**TOWN OF BROOKLYN
PLANNING AND ZONING COMMISSION
Regular Meeting Agenda
Wednesday, March 1, 2023 6:30 p.m.**

- a. Reading of Legal Notices:**
 - b. Continued Public Hearings:**
 - 1. **SP 22-008:** Special Permit Application for Multi-Family Development (50 Condominium units) on south side of Louise Berry Drive (Assessor's Map 33, Lot 19), 13.5 acres, R-30 Zone, Applicant: Shane Pollack and Erin Mancuso.

DESIGNED: DBB	REVISIONS:
CHECKED: DRB	2023-02-08 TOWNS COMMENTS
JOB NO: 22172	DATE: NOVEMBER 30, 2022
SCALE: 1" = 20'	SHEET: 5 OF 6

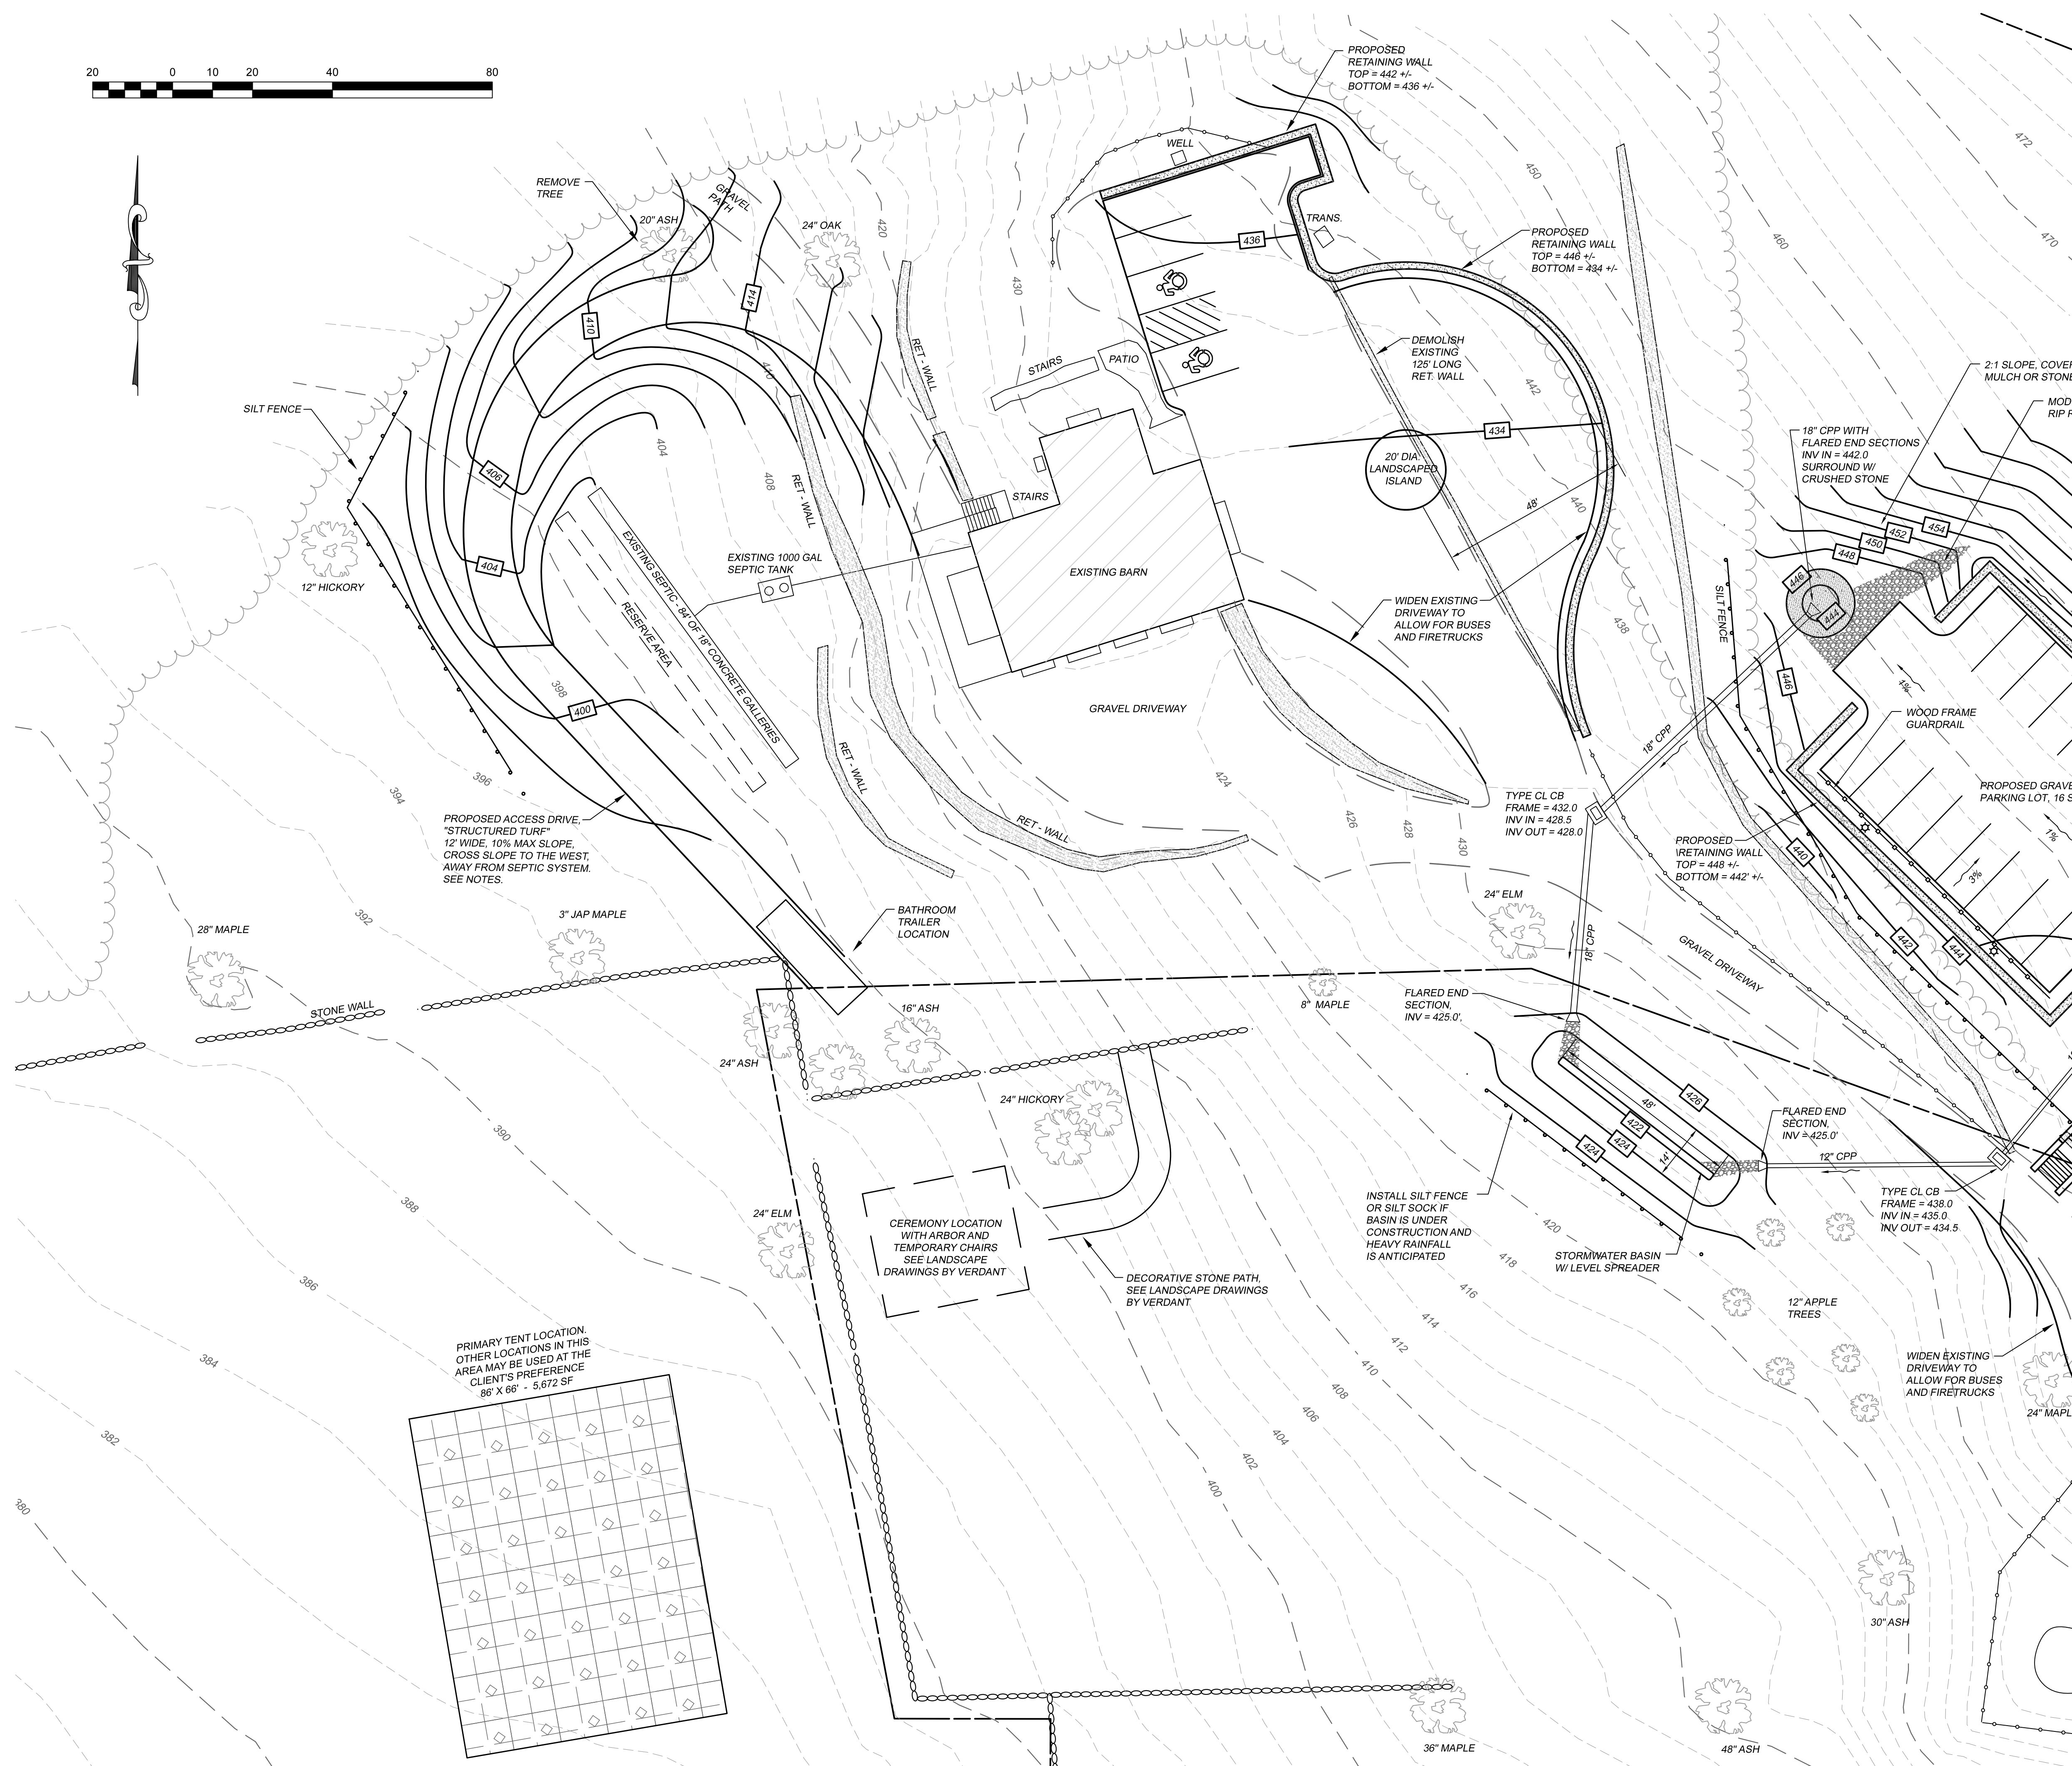
8. A paved driveway apron is required by the town Public Improvement Specifications and is missing on this plan and the architect's plan. This needs to be added to each plan with a construction detail added to Sheet 6 of 6.

8. There are no aprons shown on this sheet, we assume this comment refers to the previous sheet where the proposed gravel driveway connects with Wolf Den Road. The Parking Lot Plan has been revised to specify a paved apron, and a detail has been added to Sheet 6. Please note that the existing road has a slope of approximately 11%, therefore the proposed driveway apron must have a cross slope of 11% also. However, the slope along the length of the driveway will be 3% for the first 20 feet.

DATE: NOVEMBER 30, 2022
SHEET: 6 OF 6

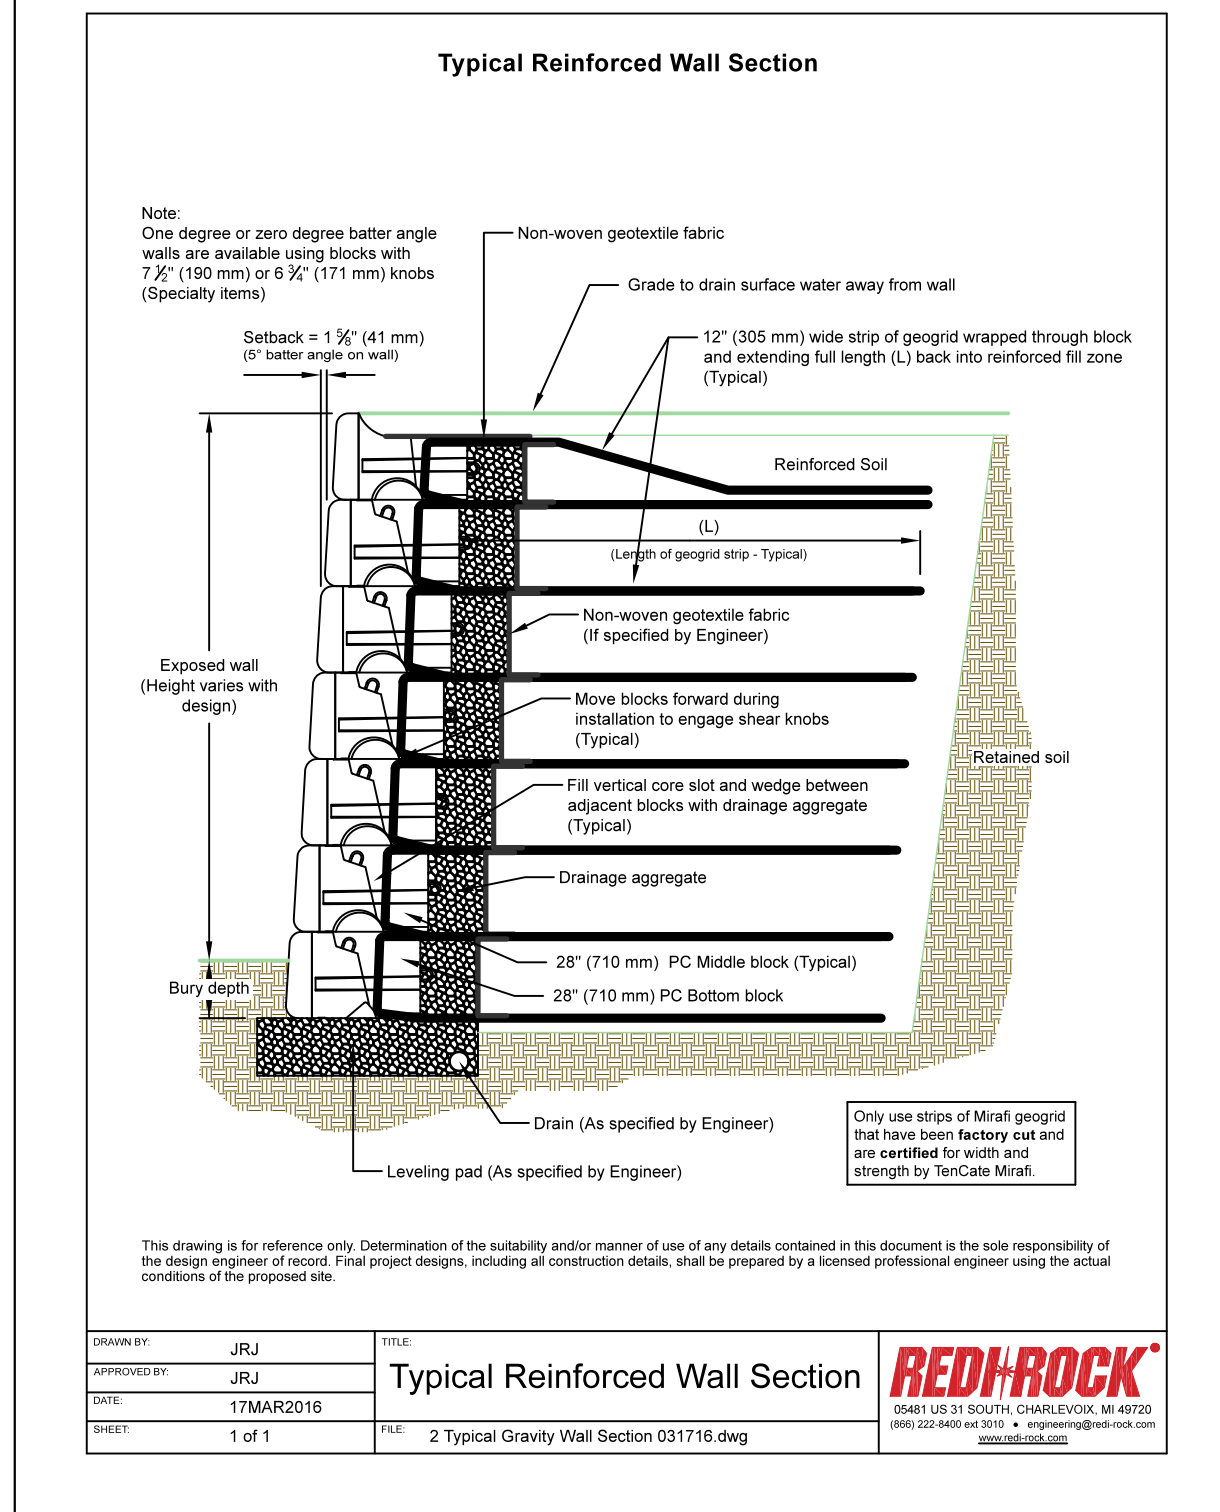
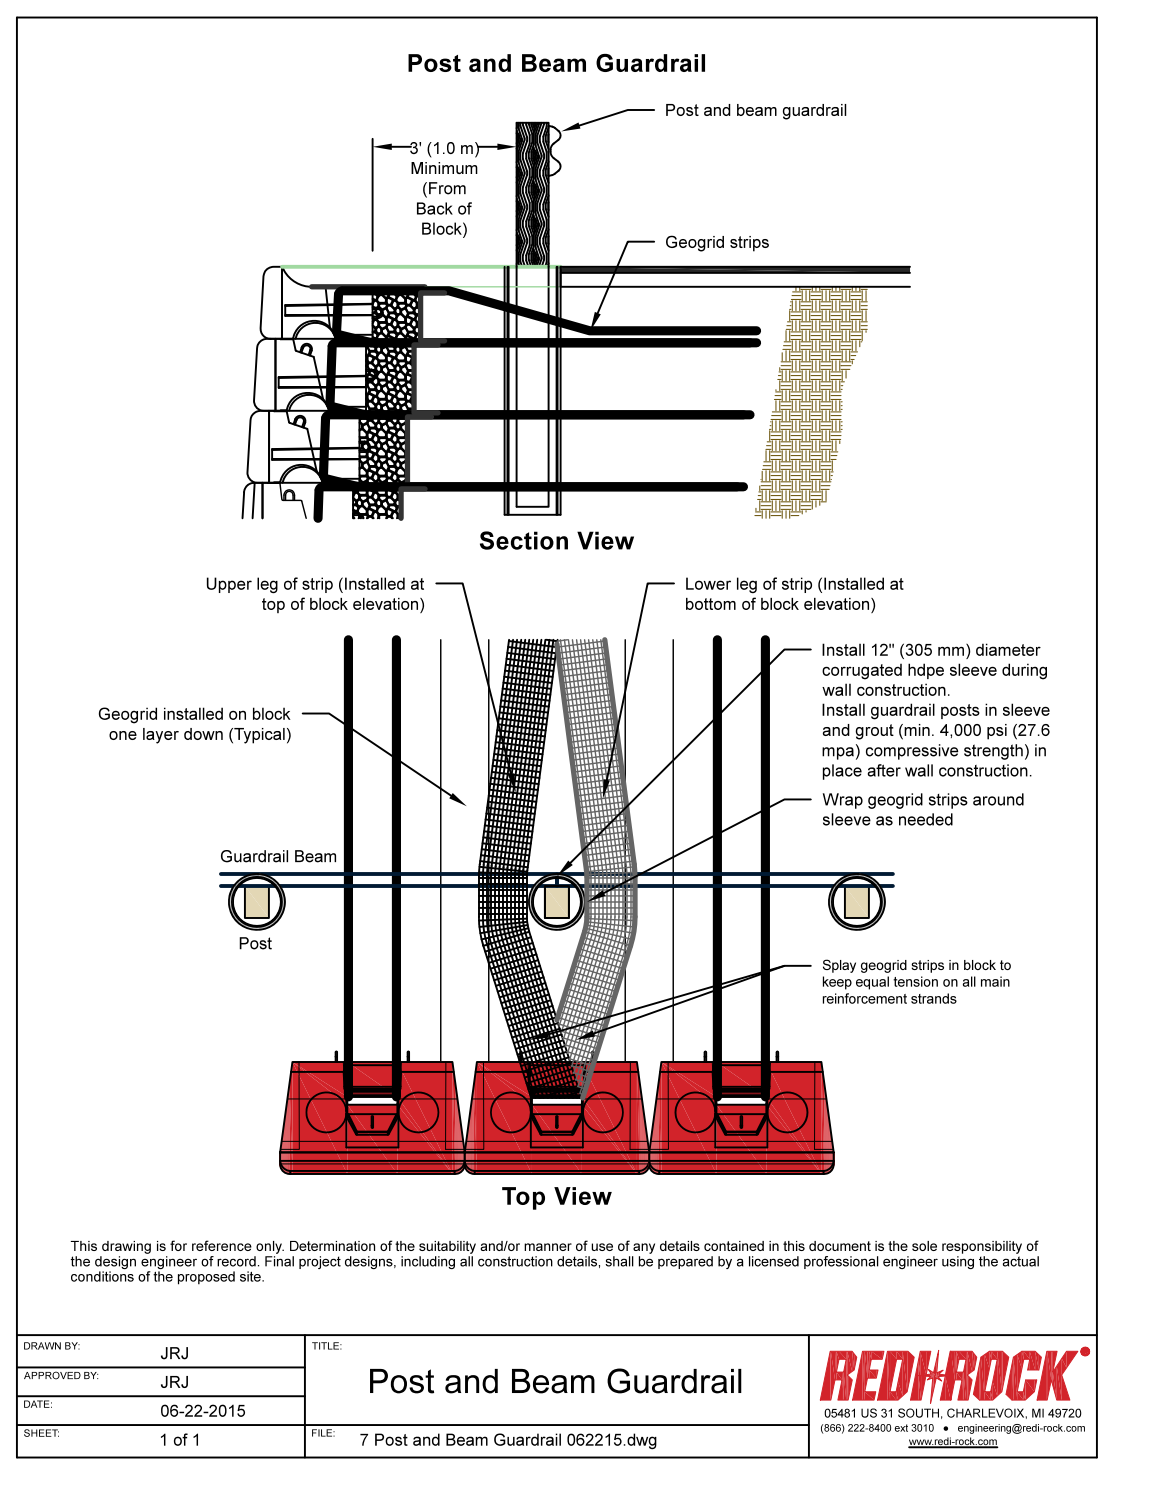
9. How is the "Access Drive of Structured Earth" going to be delineated since it will be covered with grass? What is the basis for the design composition of structured earth described under "Structured Turf Notes" to understand its durability? A detail drawing needs to be included on Sheet 6 of 6.

5. A “grass swale” detail needs to be included on this sheet.
6. This plan calls for a gravel surface parking lot but the Verdant Landscape Architecture plan (Drawing LP1) calls for crushed stone. Which is it? How will crushed stone perform under the stress of a snowplow if that is what will be installed?
